SSDA Submission Report

Griffith Base Hospital Redevelopment

Health
Infrastructure

Revision 5

Figure No. 2 – Required separation of Buildings on the Ground Floor

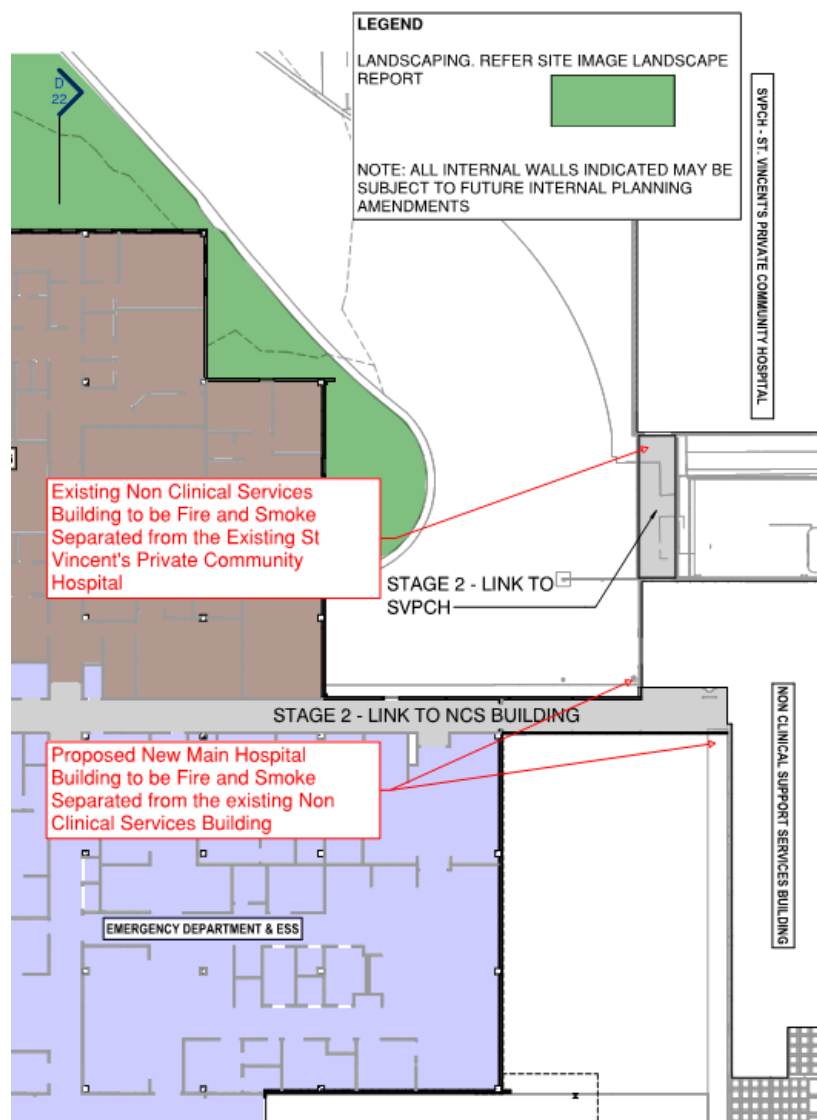
The new Clinical Services Building will be required to be adequately fire and smoke separated from the existing Non-Clinical Services Building that is directly connected to the Main Hospital Building via an enclosed linkway.

All new linkways, enclosed corridors etc will be assessed as part of the new hospital building and will be required to be adequately fire and smoke separated from the existing the hospital buildings.

Additionally, the existing Non Clinical Services Building is proposed to be connected to the existing St Vincent's Private Community Hospital via a new enclosed linkway. Fire and smoke separation of the two existing buildings will be required to be provided as a result of the new linked connection.

Figure No. 3 – Non required non-fire isolated stairway within the Front of House connecting Ground Level to Level 1

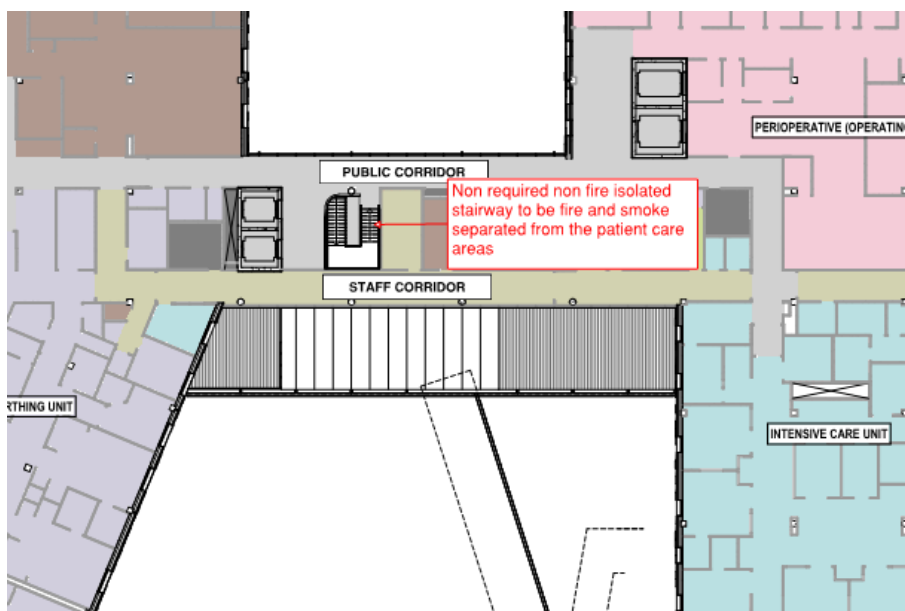
The proposed non-required non-fire isolated stairway situated within the Front of House area which connects Ground Floor to Level 1 is permitted in accordance with the DtS Provisions on the basis to all patient care areas being fire and separated from the front of house area in which the open stairway directly connects together with the fact that the building is sprinkler protected and the stairway discharges at Ground Level at which there is direct egress to a road or open space.

No patient care areas can be directly connected to or open onto the front of house area without being fire separated.

The discharge of horizontal exits into the front of house area occupied by the non-required non-fire isolated stairway and void will be required to be assessed as part of the Fire Engineering Strategy developed for the building. This will be undertaken and completed as part of the s6.28 Crown Certification process following SSDA Approval.

Figure No. 4 – Proposed location of Fire Hydrant Booster relative to the Main Building Entry

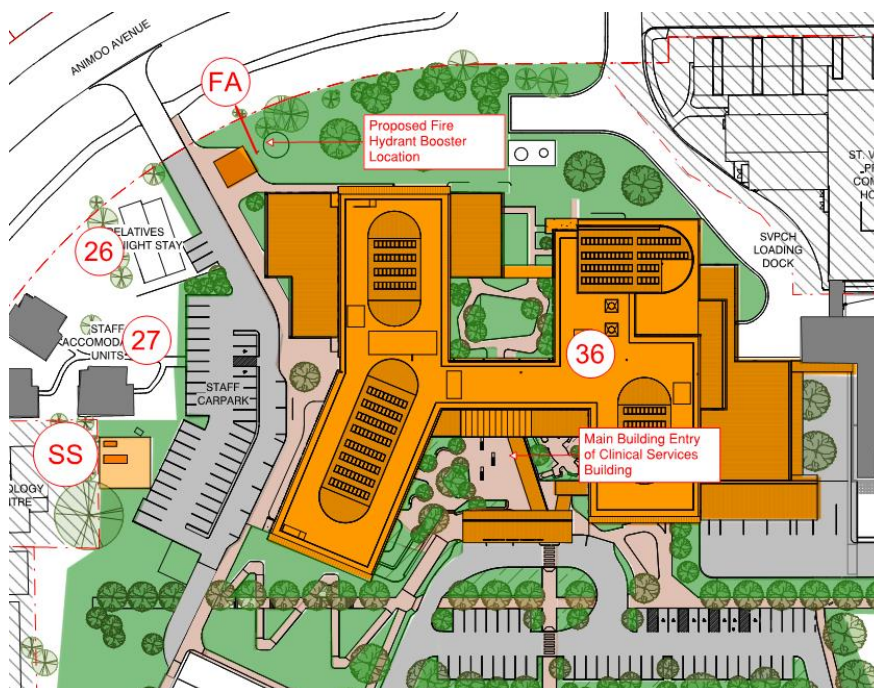
A fire hydrant booster needs to be located in a manner where it is within sight of the main entrance of the building and adjoins a primary vehicular entrance and is situated within 8m of a hardstand access to permit Brigade access.

It is noted that the proposed location of the fire hydrant booster is at the site entry point from Animoo Avenue as detailed in the figure below. The proposed location of the fire hydrant booster will not be within sight of the main entrance of the building.

The location of the fire hydrant booster in terms of proximity and sight to the main entrance of the building will be required to be assessed as part of the Fire Engineering Assessment to be undertaken by the appointed Fire Safety Engineer in order to demonstrate compliance with the nominated Performance Requirements of the BCA. This will be undertaken and completed as part of the s6.28 Crown Certification process following SSDA Approval.

Figure No. 5 – Proposed location of Fire Sprinkler Booster relative to the Main Building Entry

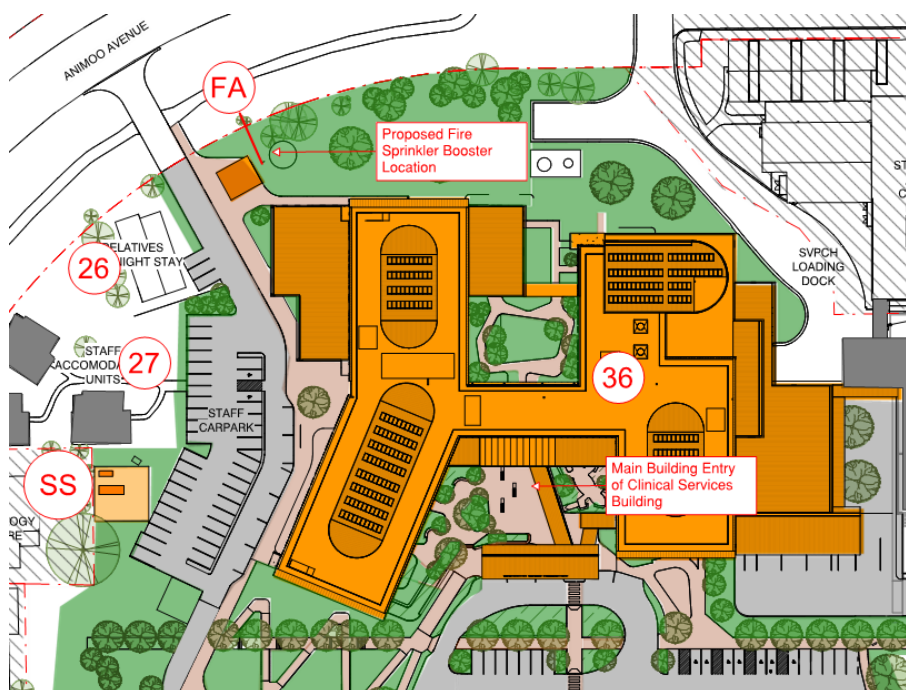
A fire sprinkler booster needs to be located in a manner where it is within sight of the main entrance of the building and adjoins a primary vehicular entrance and is situated within 8m of a hardstand access to permit Brigade access.

It is noted that the proposed location of the fire sprinkler booster is at the site entry point from Animoo Avenue as detailed in the figure below. The proposed location of the fire sprinkler booster will not be within sight of the main entrance of the building.

The location of the fire sprinkler booster in terms of proximity and sight to the main entrance of the building will be required to be assessed as part of the Fire Engineering Assessment to be undertaken by the appointed Fire Safety Engineer in order to demonstrate compliance with the nominated Performance Requirements of the BCA. This will be undertaken and completed as part of the s6.28 Crown Certification process following SSDA Approval.
